Sheet: /
File: h2cboard.kicad_sch

Title: HDMI2SCART

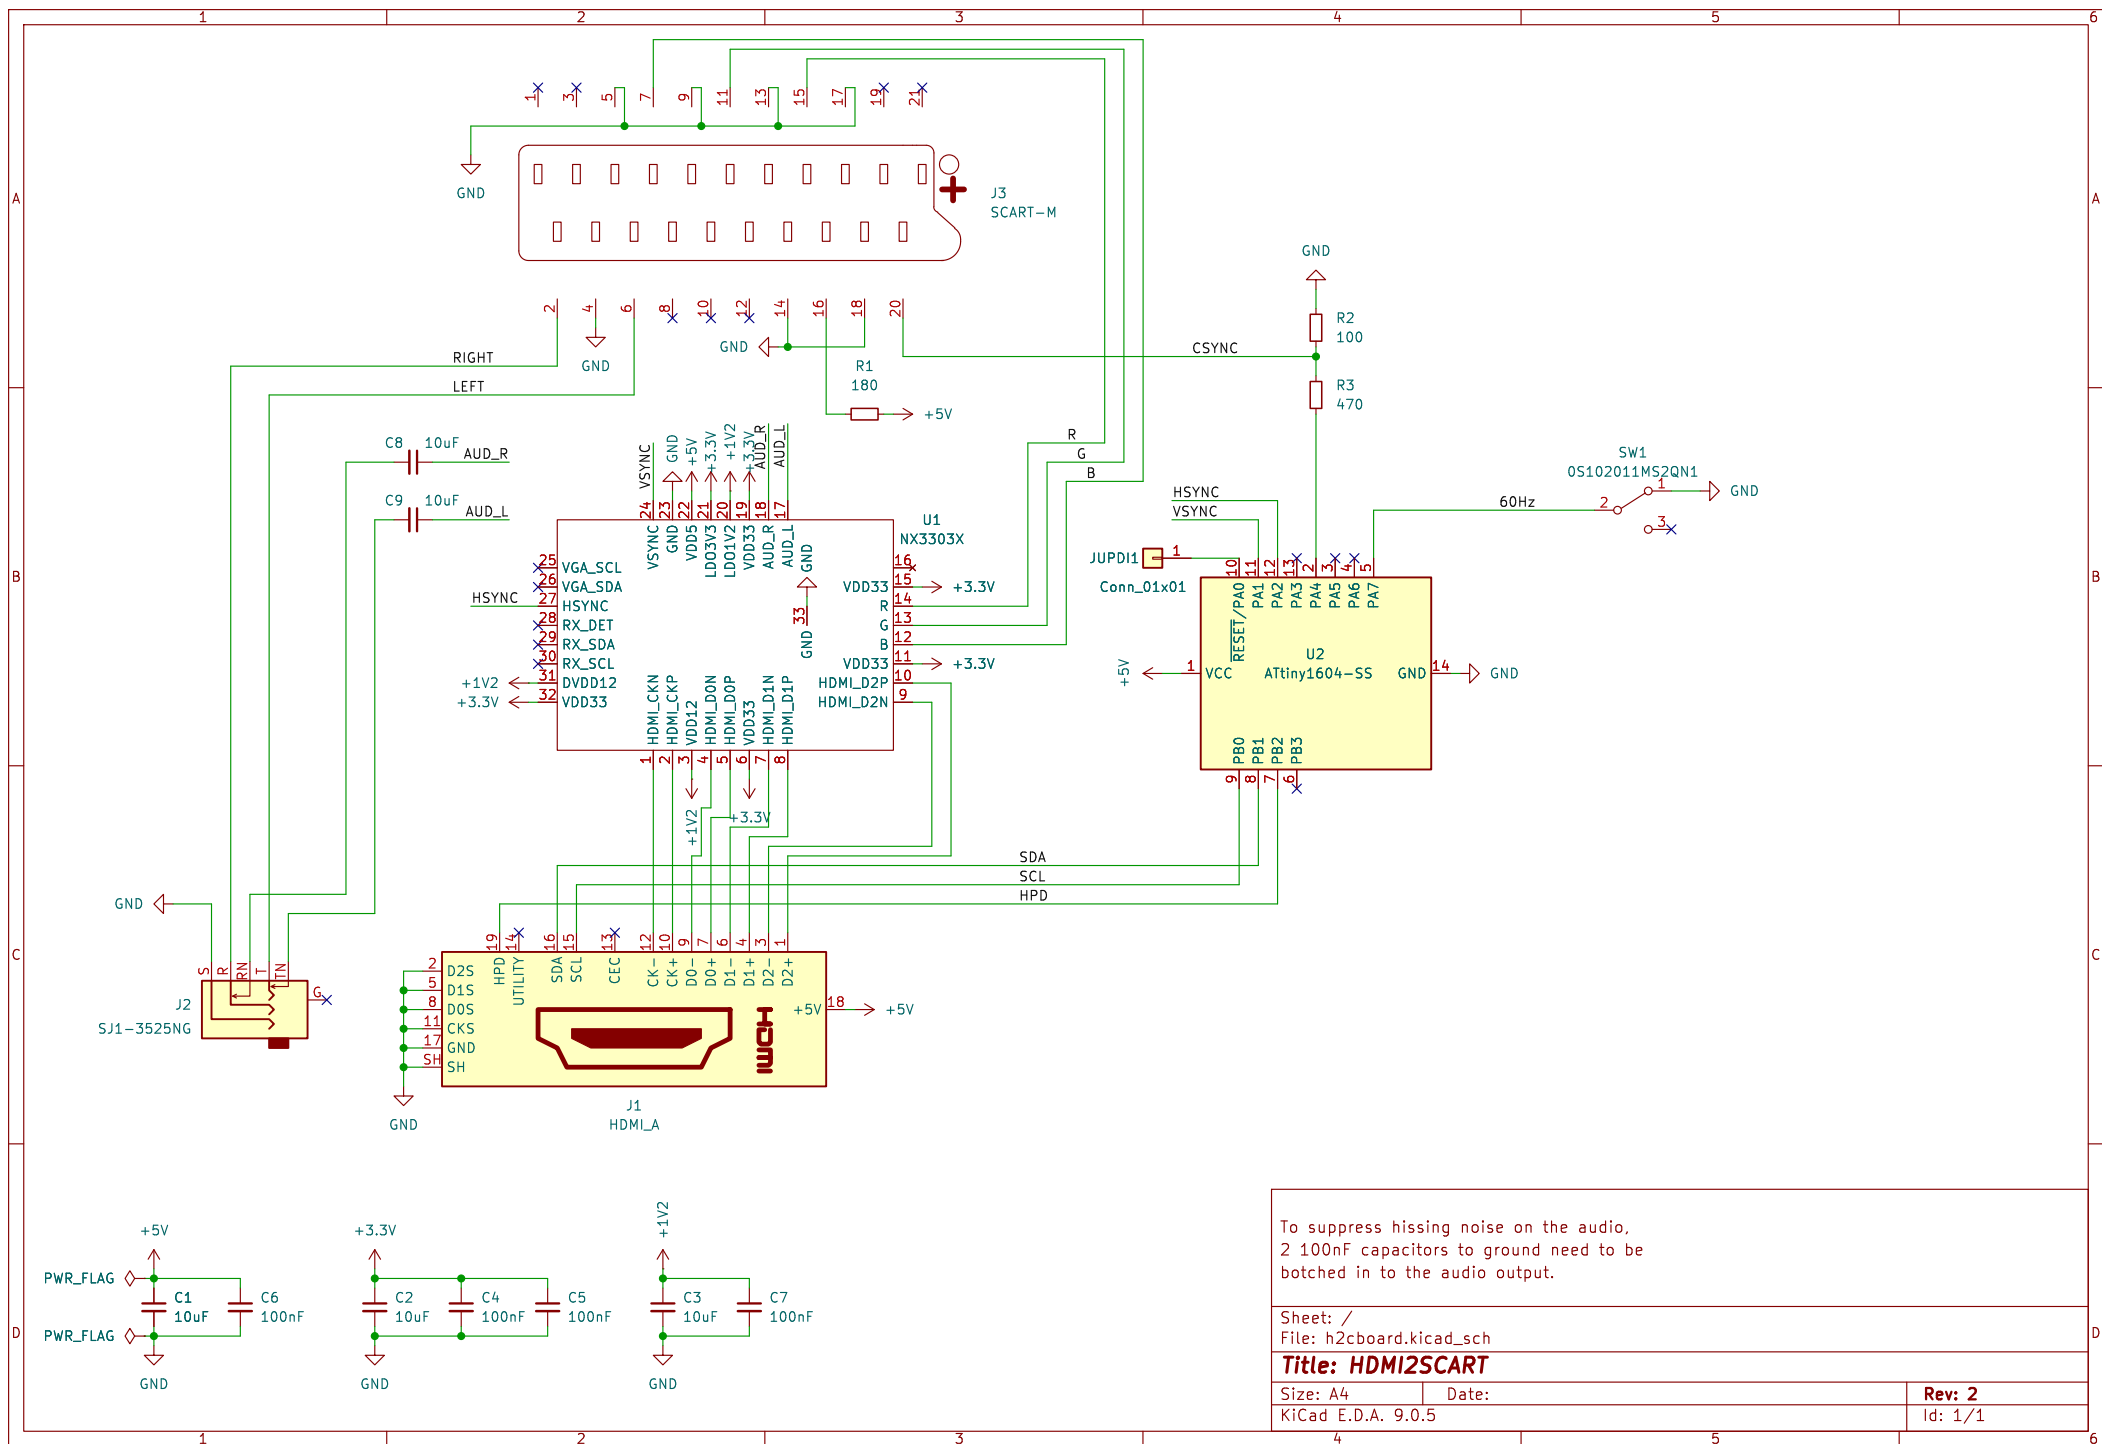
To suppress hissing noise on the audio,
2 100nF capacitors to ground need to be
botched in to the audio output.
